**TOWN OF MOUNTAIN VILLAGE  
REGULAR DESIGN REVIEW BOARD MEETING  
AGENDA**

**THURSDAY SEPTEMBER 3, 2020 10:00 AM**

**TO:** Mountain Village Design Review Board  
**FROM:** John Miller, Senior Planner  
**FOR:** Design Review Board Public Hearing; September 3, 2020  
**DATE:** July 23, 2020, *Updated August 21, 2020*  
**RE:** Staff Memo – Initial Architecture and Site Review (IASR) Lot 630

**EXTERIOR LIGHTING PLAN**

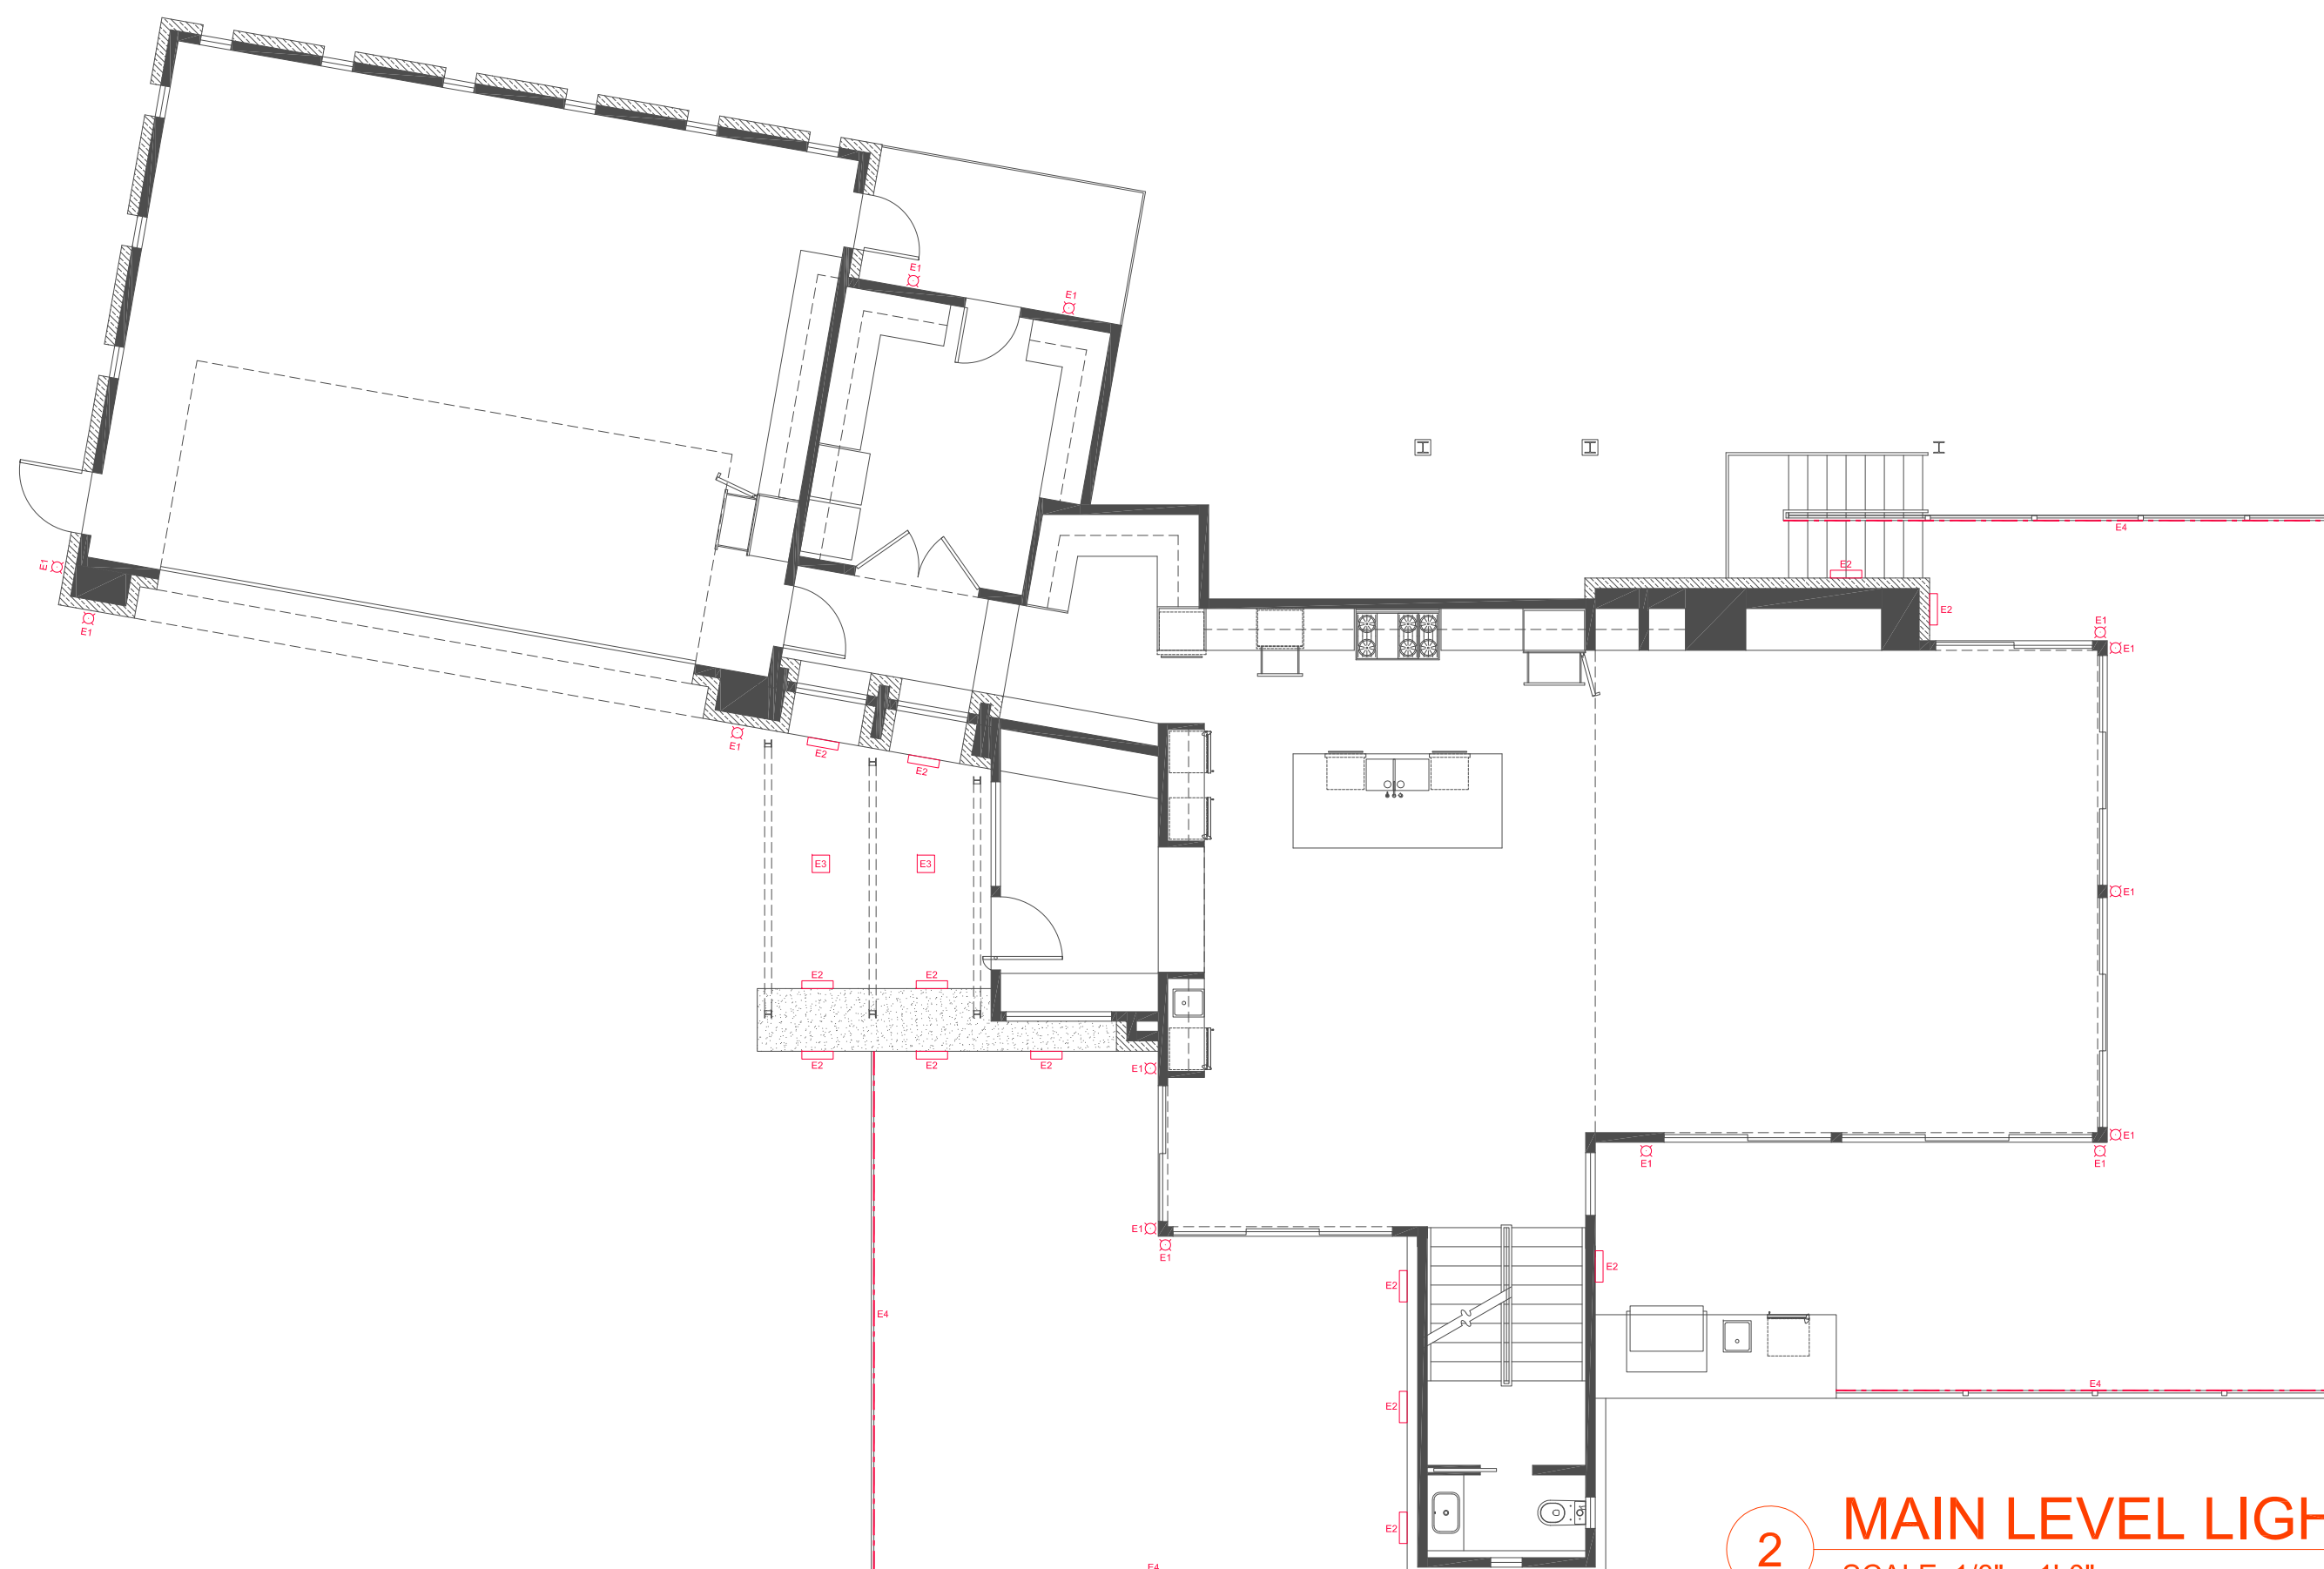
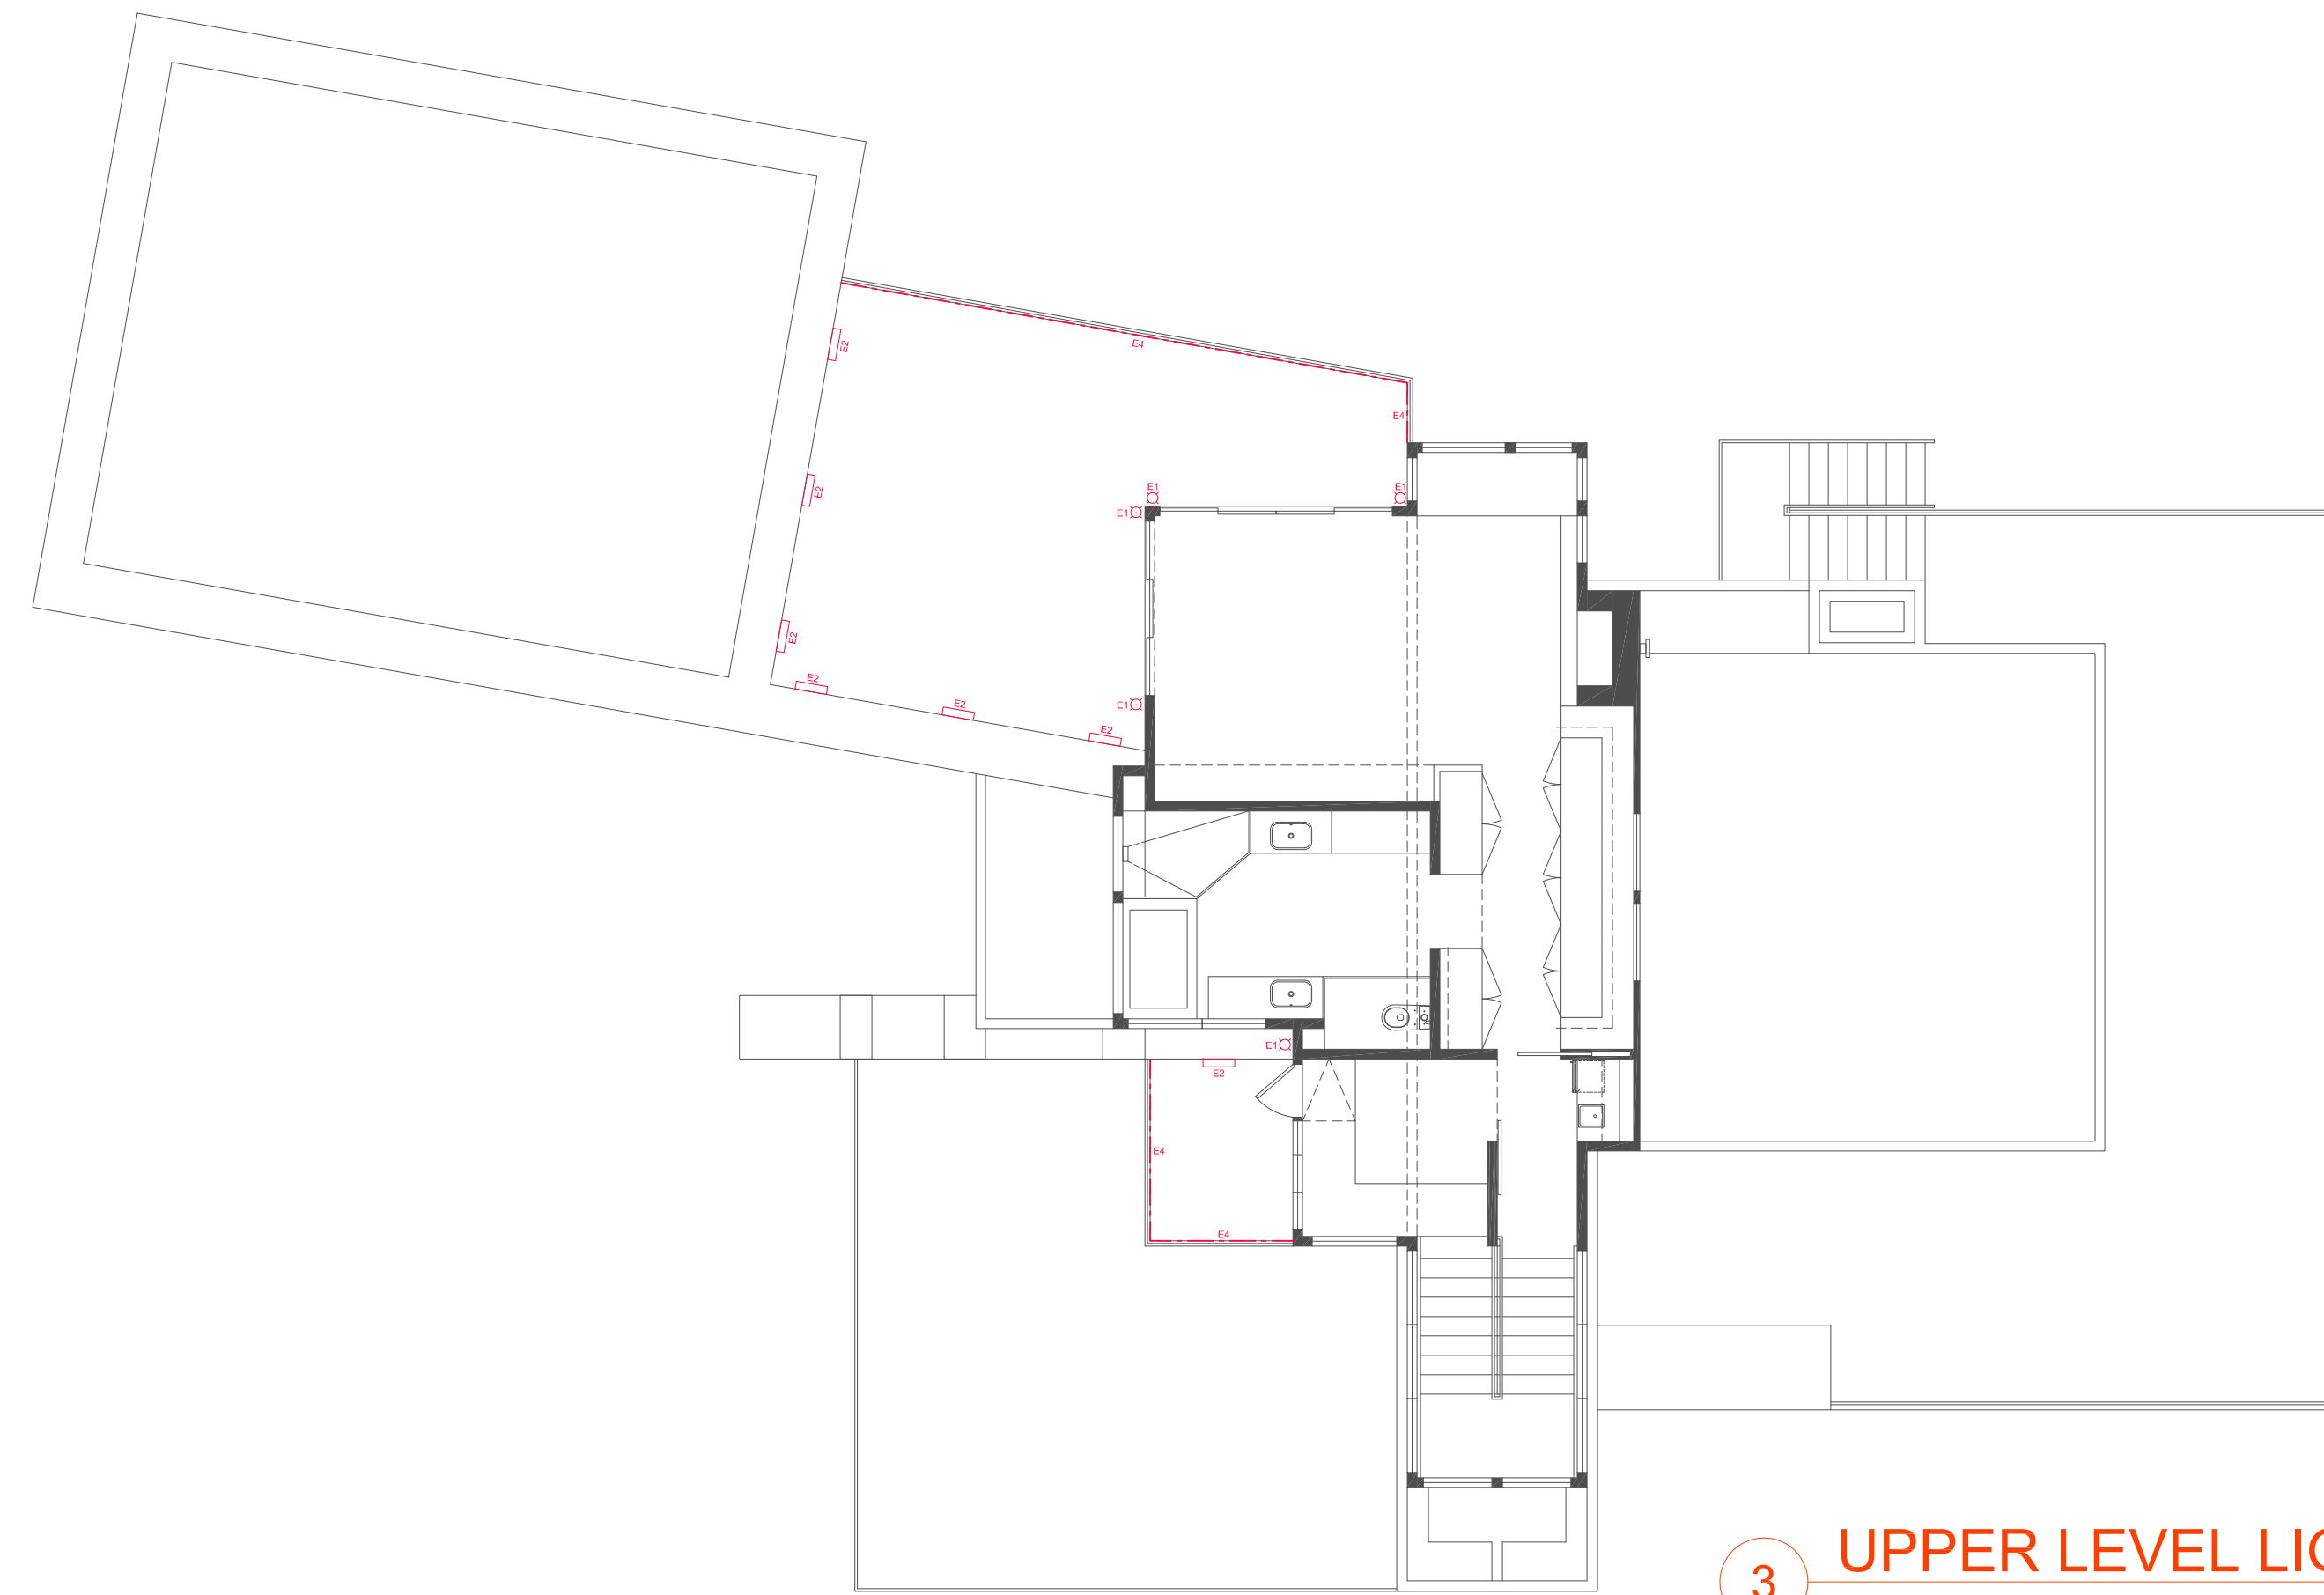
*Staff: The applicant has provided a preliminary lighting plan demonstrating the locations and types of fixtures at a very high level. There were a number of recommendations made at the July hearing regarding fixtures, dimmers, and overall lighting and the applicant intends to make those changes prior to FAR. It should be noted that the Lighting Plan is not required at IASR.*

- 3) Prior to the submittal for a Final Architectural Review, the applicant shall provide a detailed lighting plan to include specific fixture cut sheets, dimmer switch details, and a photometric study of the Lot demonstrating compliance with the CDC lighting standards.
